# Rufus 2.0 - Block 19

## Purpose of Recommendation Meeting #3

FIGURE 3H

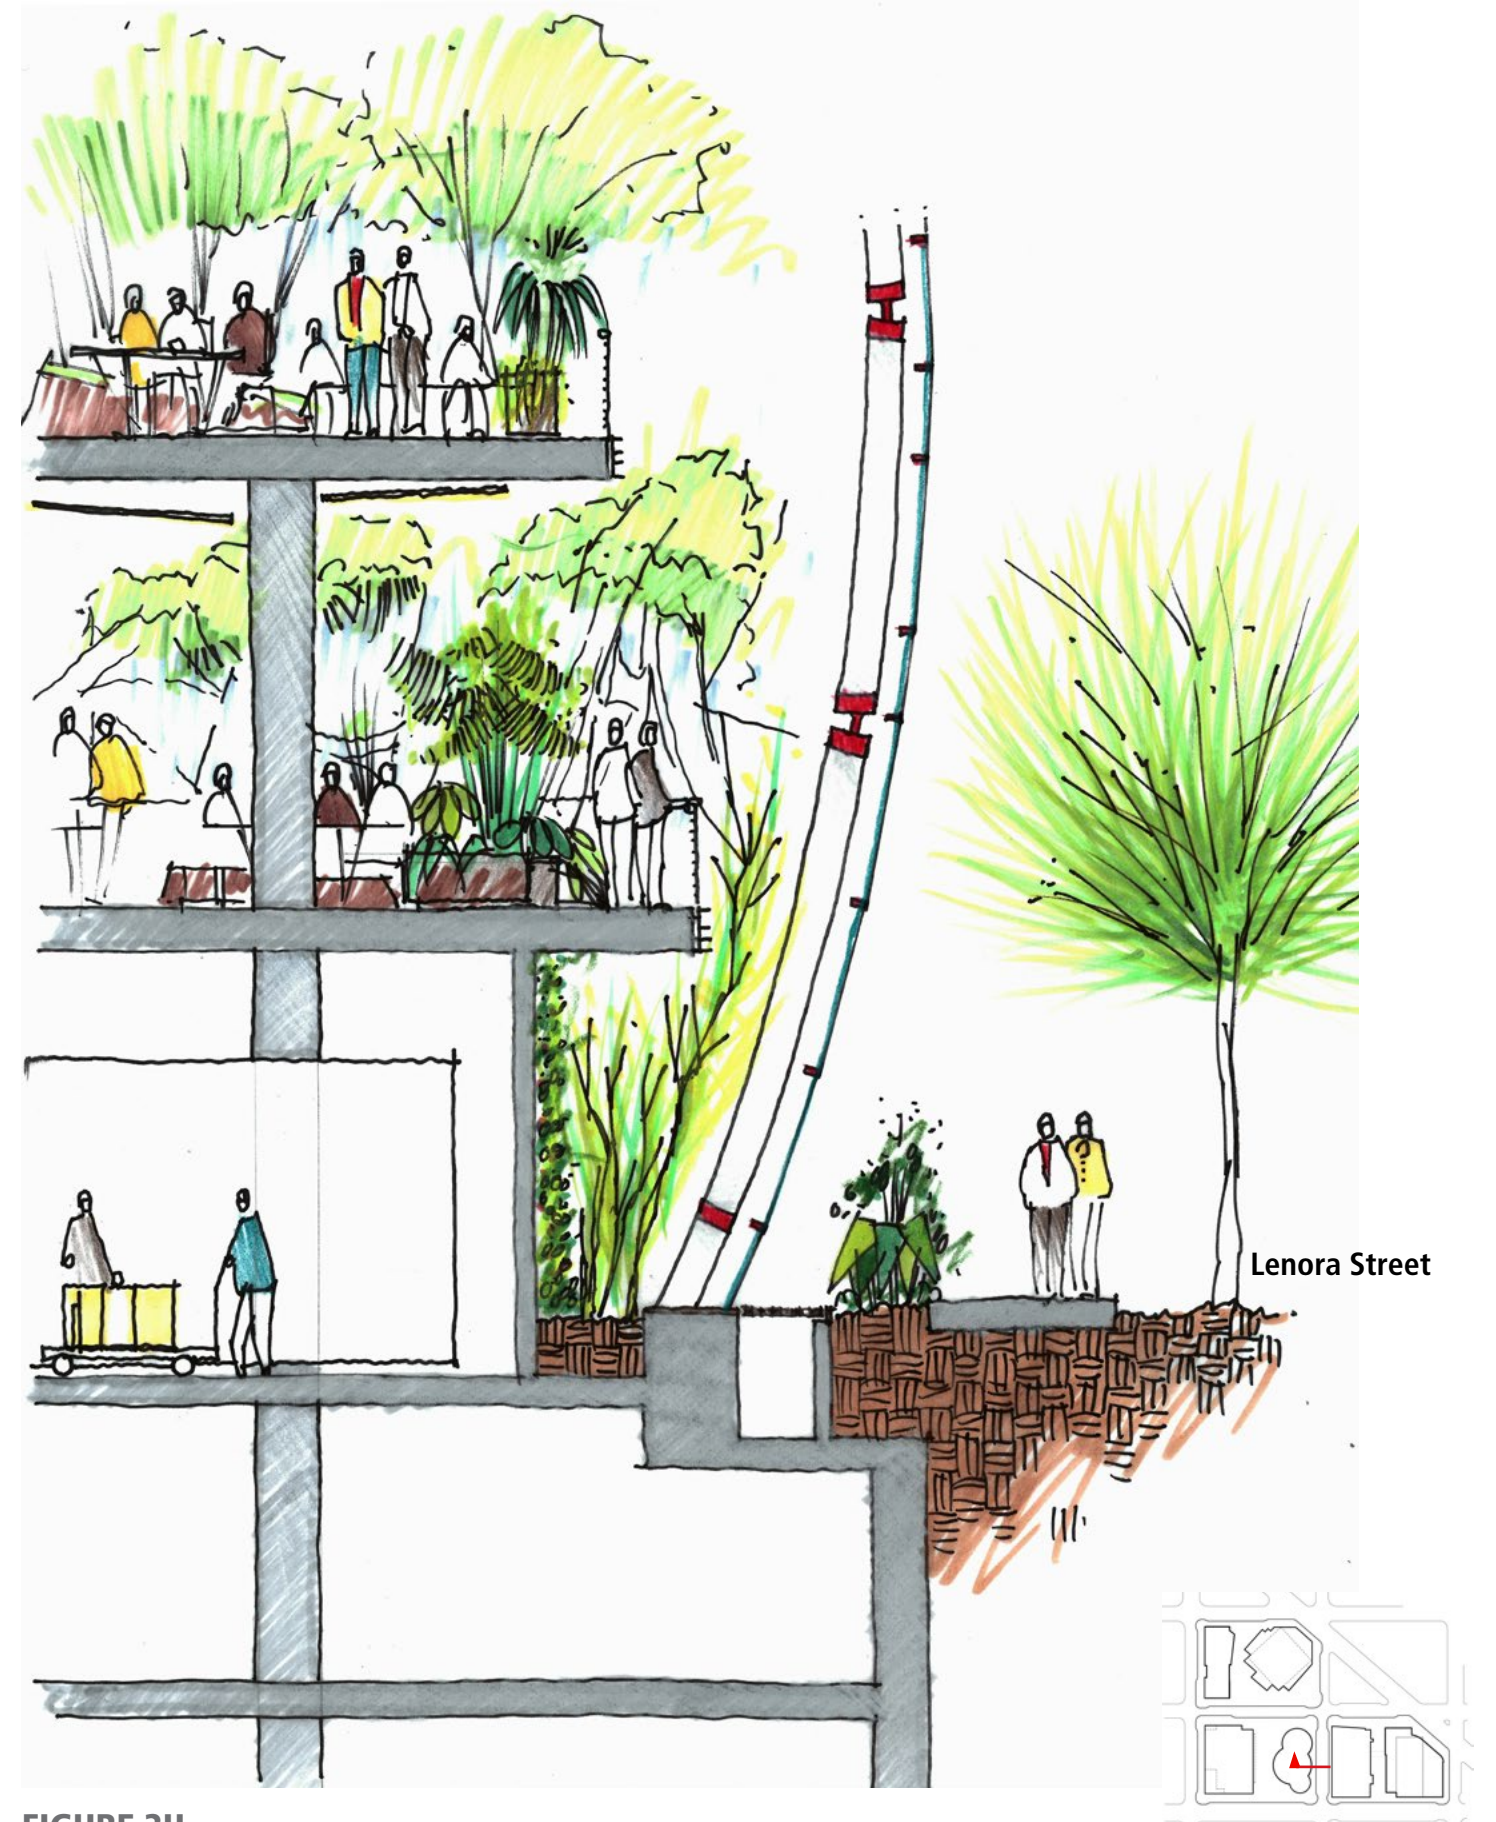
d. The Board would like to see detailed sections of the Lenora experience at the next meeting (similar to page 20 of the booklet) showing sidewalk, landscaped and hardscaped area, and building section. (C-1, D-1, D-2)

Detailed sections shown in Figures 3G and 3H and a physical section model shown in Figure 2A have been provided.

FIGURE 4A

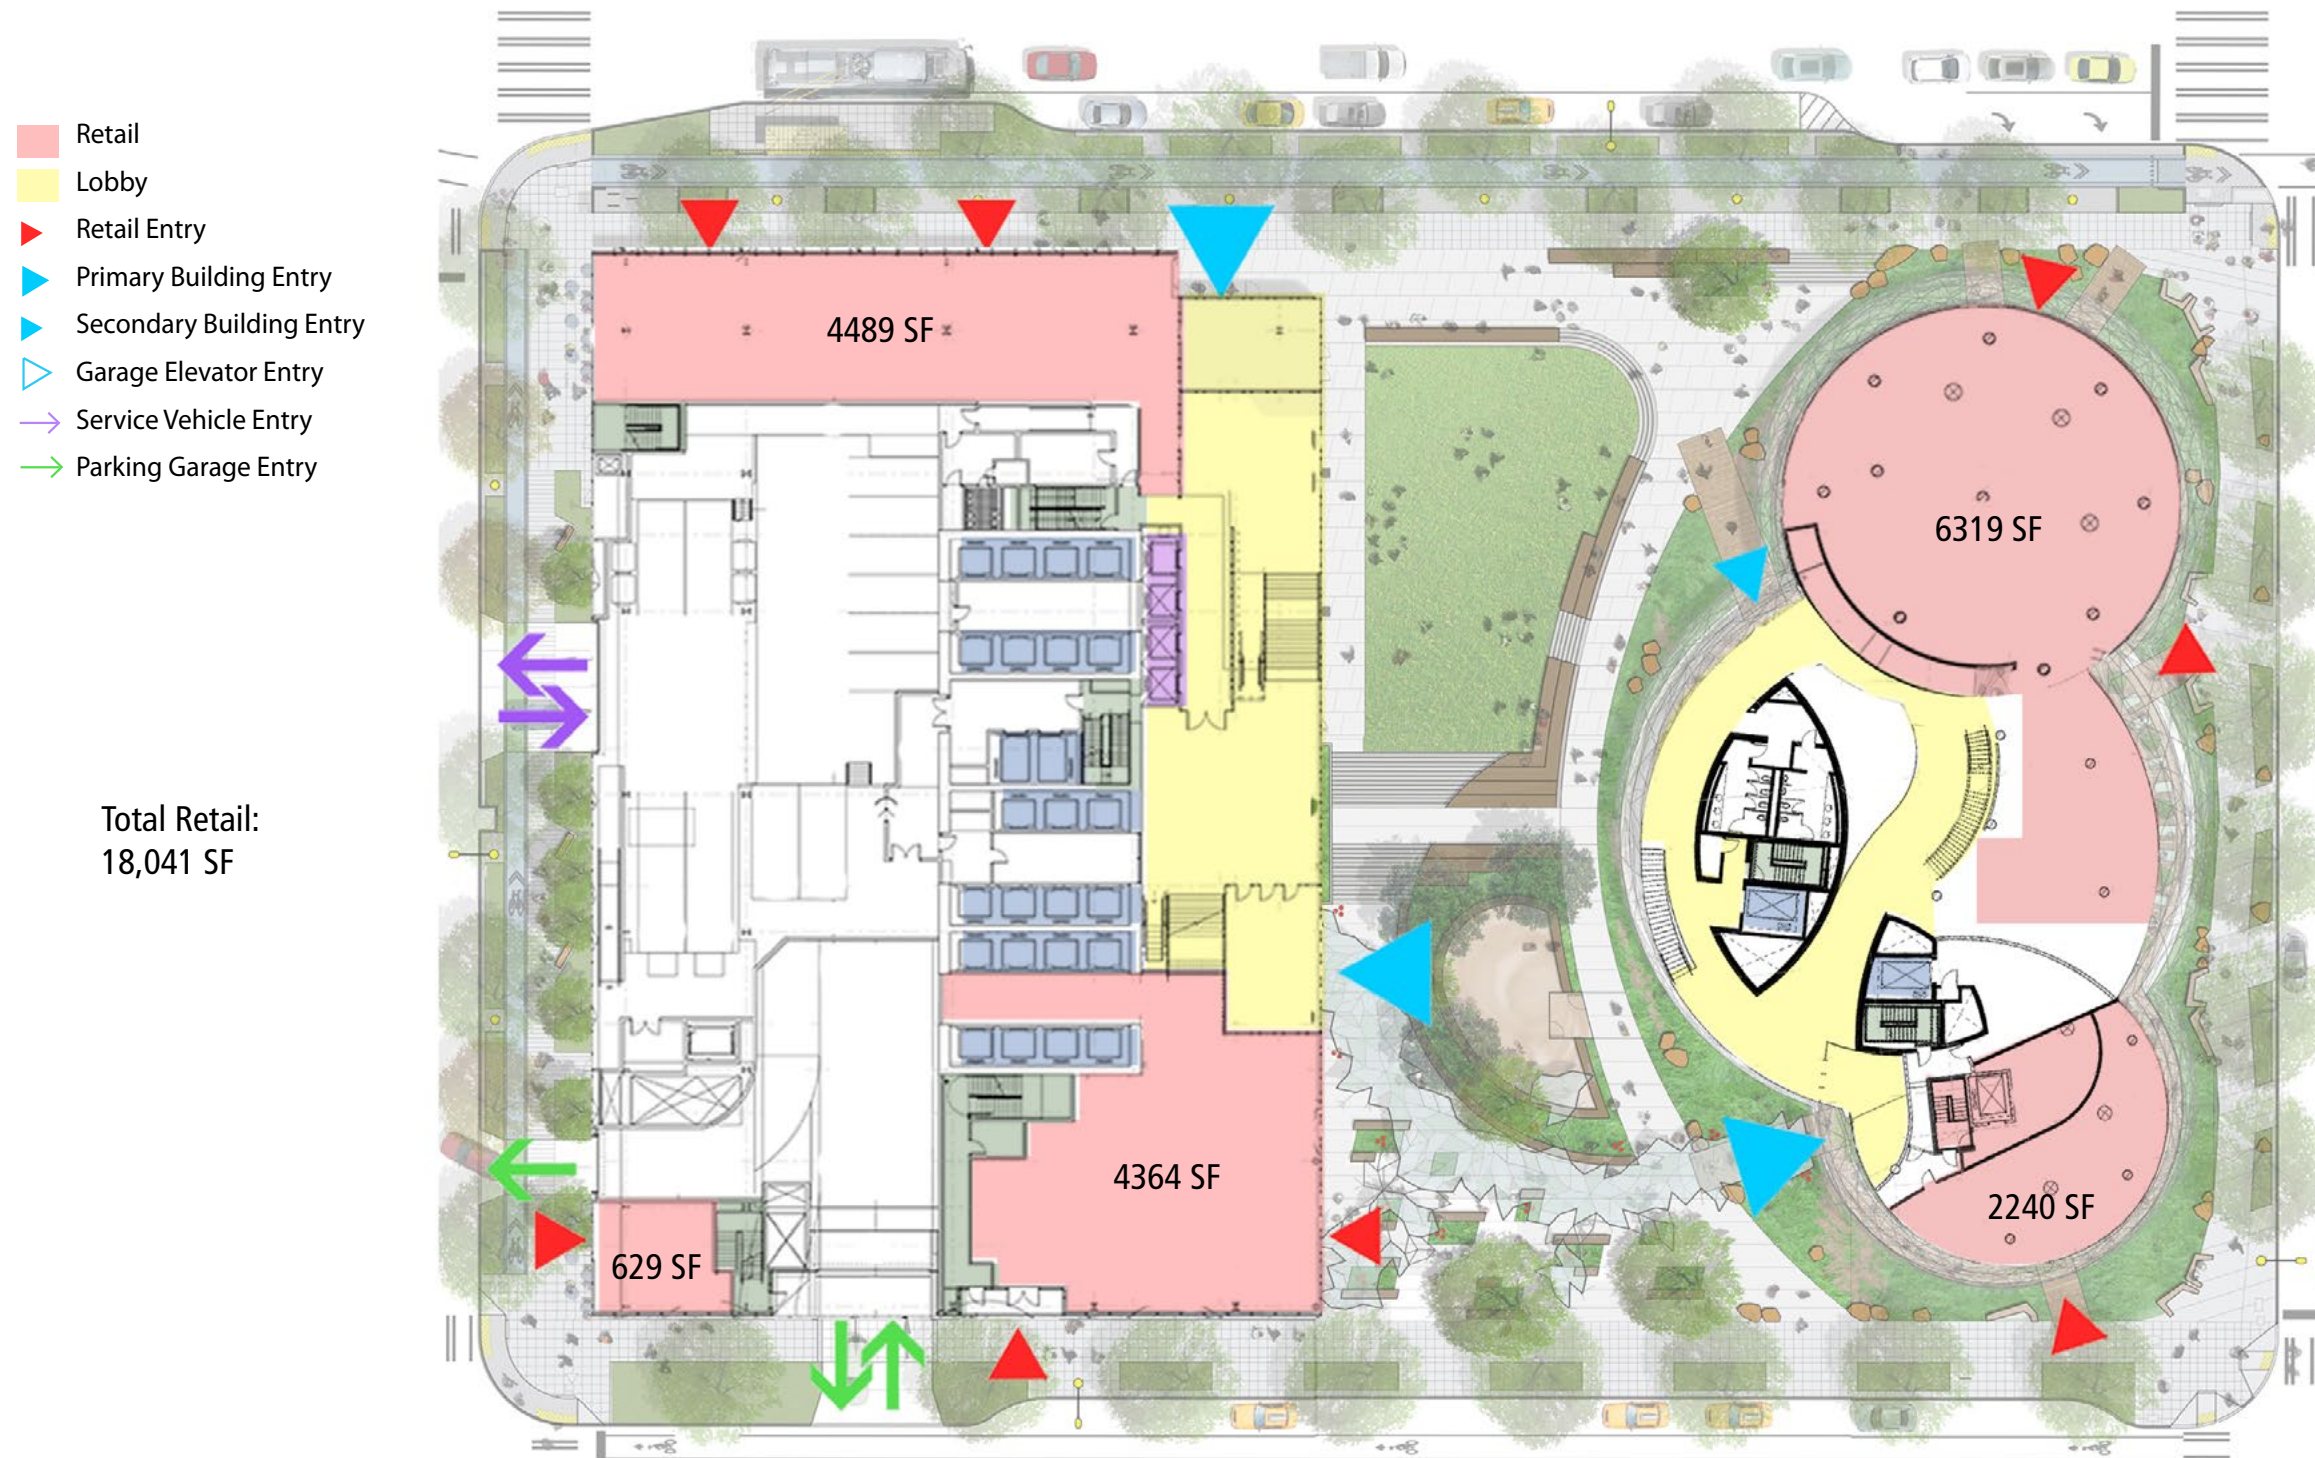
d. The Board clearly stated that the retail spaces should be well-considered to accommodate functional and successful retail activity. Part of this consideration demands that the pinch points within the retail configuration need to be resolved. (C-1, C-4, D-3)

An updated retail and access plan is shown in Figure 4A.

FIGURE 4B

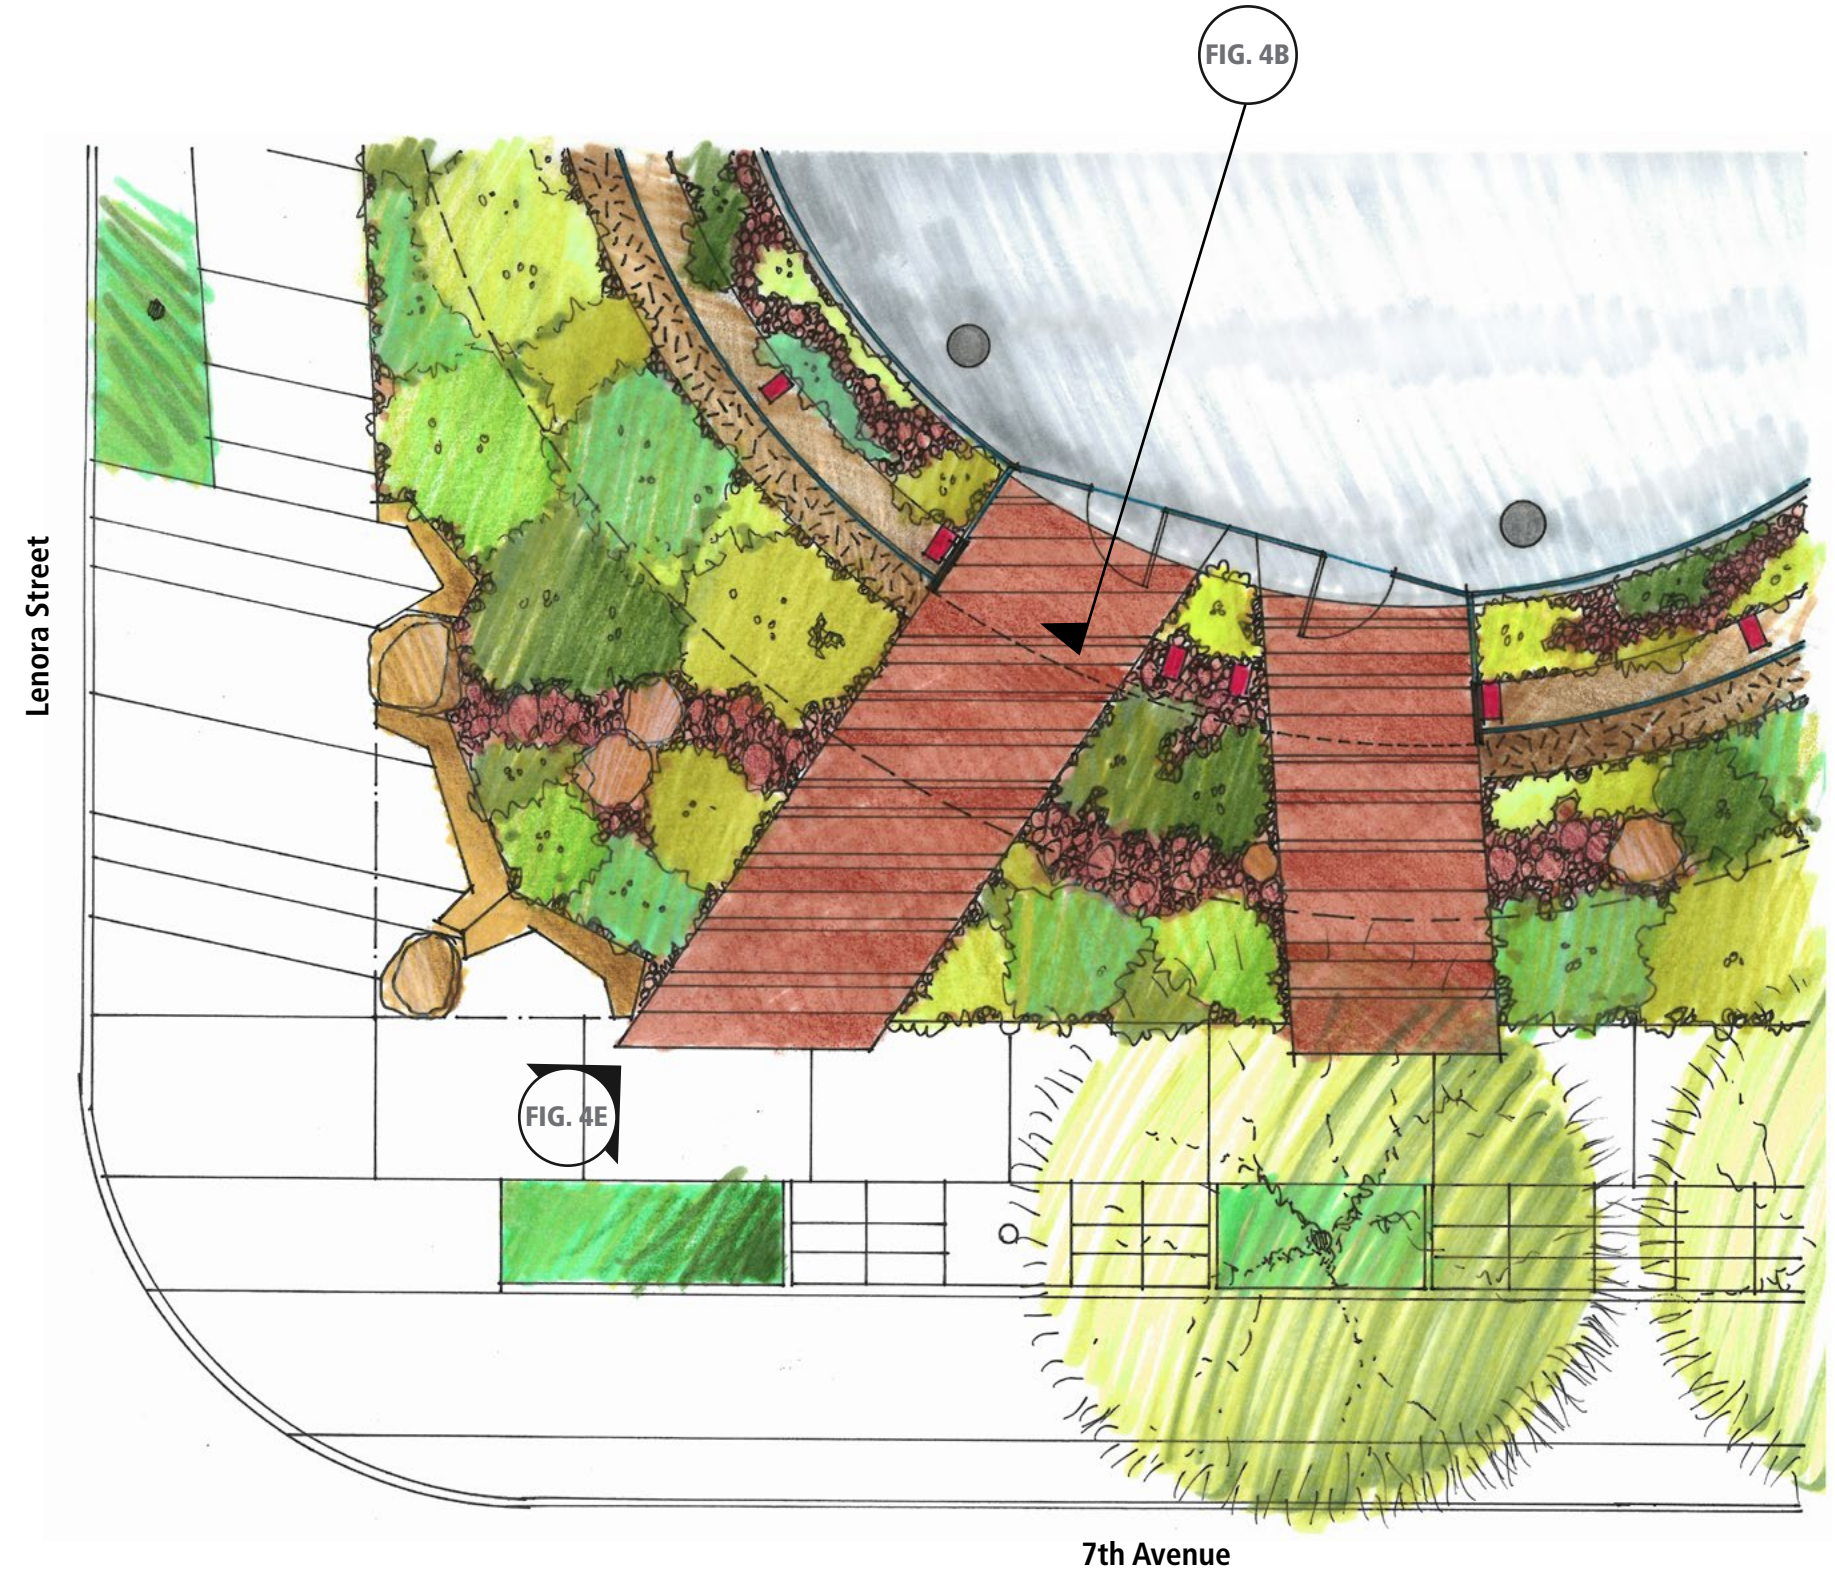
c. The Board encouraged an observable gap between the retail ceiling and the building skin as shown on page 20 of the presentation booklet to allow visibility at the retail entry points to the unique qualities of the structure and space. (C-1, C-4, D-3)

Figure 4B depicts the condition at a typical retail entry.
